UNITED STATES PATENT AND TRADEMARK OFFICE

10/748,857

Office Action Summary

DETAILED ACTION

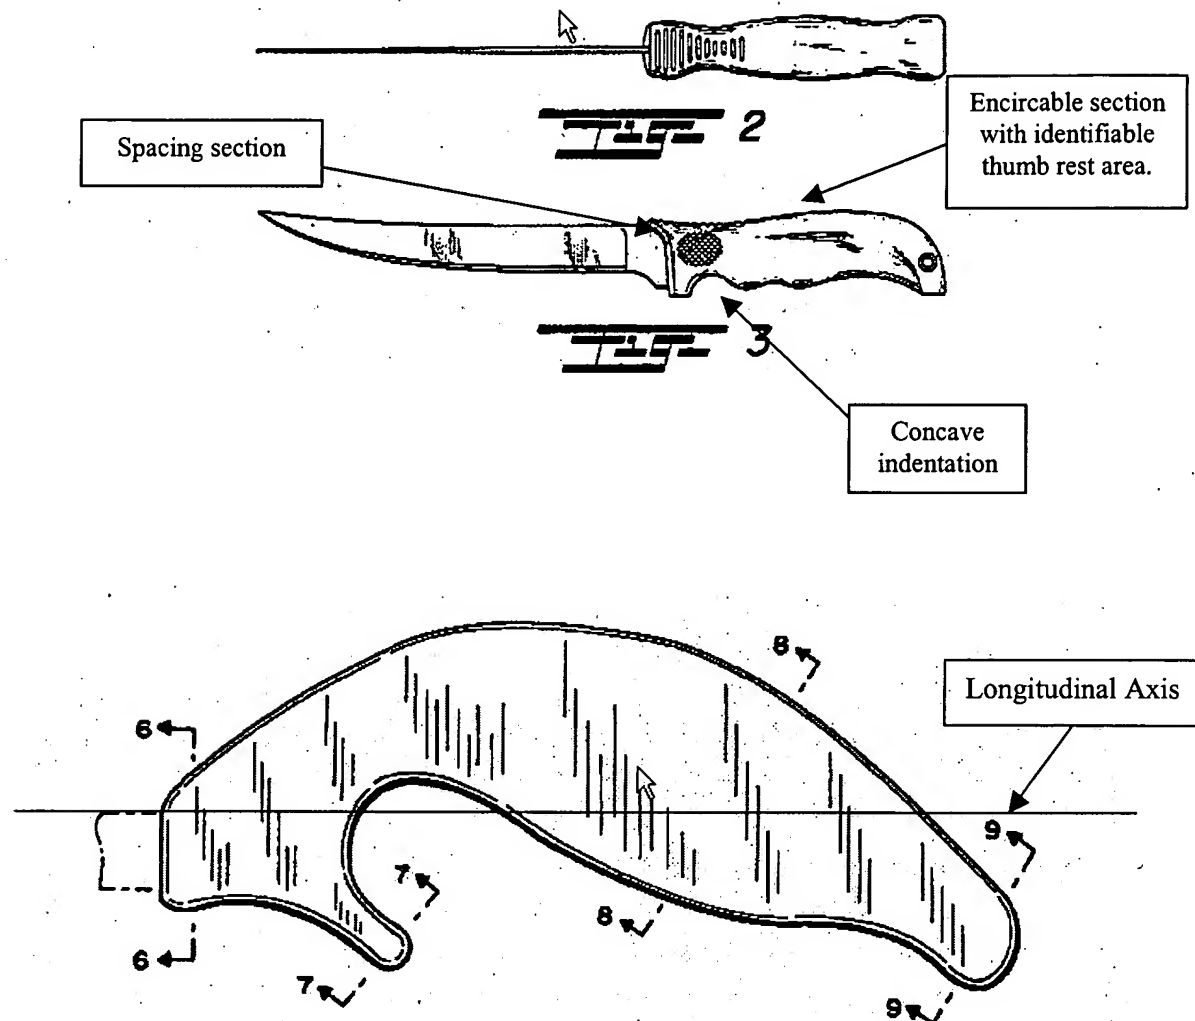
See below figures. Herron provides the general claimed handle including a generally elongated body defining a body longitudinal axis, a body forward end for connection to said implement head and a longitudinally opposed body rearward end; said body also defining a body top surface and a substantially opposed body

bottom surface; said body defining an encirclable section located intermediate said body forward and rearward ends, said encirclable section being configured and sized so as to be graspable between at least a portion of a user's palm and at least a portion of at least either one of the user's middle, ring or small fingers at least partially encircling said encirclable section; said body top surface being provided with an identifiable thumb rest area located intermediate said encirclable section and said body forward end for contacting at least a portion of the distal pulp of said thumb, said thumb rest area defining a rest area forward most location; said body bottom surface being provided with a substantially concave indentation defining an indentation surface located intermediate the encirclable section and said body forward end for contacting at least a portion of one of said finger lateral surfaces of said index finger with the latter in substantially perpendicular relationship with said body longitudinal axis; said indentation surface having a substantially arcuate cross-sectional configuration defining an indentation first end located substantially adjacent said encirclable section and an indentation second end located substantially adjacent to said body forward end; said body defining a cross-sectional first reference plane extending in a substantially perpendicular relationship with said body longitudinal axis and in register with said indentation second end, said indentation surface being configured and sized so that at least a section of said

indention surface is positioned forwardly relative to said first reference plane. The thumb rest is offset relative to the indention, as claimed. The encirclable section is fusiform. An abutment section and the neck section together defining a thumb rest area on the body top surface, and an index rest area on the body bottom surface; said abutment section tapering forwardly into a spacing section for spacing the fingers from the implement head. The neck section defines a top surface nadir and a bottom surface nadir, as claimed. Top surface and bottom surface peaks as claimed are inherent.

Regarding claims 1-3, 6-14, 16, 18, 19, 26-28, 33, and 35-37, Herron provides the claimed invention except explicit teaching of (1) at least a section of the intention surface being located forwardly to a reference plan intersecting an indention surface end point, as claimed; and (2) the encirclable section having a substantially fusiform configuration, as claimed. Mosley teaches these general concepts in a particular handle design. Such a design creates a particular visual appearance that may be desired. In addition, one skilled in the art would know that the particular indentation shape provides additional shielding to the finger of a user. It would have been obvious to include such modifications in the design of Herron for the purpose of achieving a particular visual appearance of the handle as well as additional shielding means for a users finger during use of the knife.

Applicant argues that structure directed to the device of US Design Patent 397,018 is not applicable in meeting the claim limitations since the handle is curved. However, as shown in the above figure, a generally longitudinal axis can still be formed. In addition, specific aspects of the device of '018 are obviously combinable with Herron, specifically the fusiform configuration and the indentation shape, as outlined in the above rejection. Such structures are well known in the art of handles.
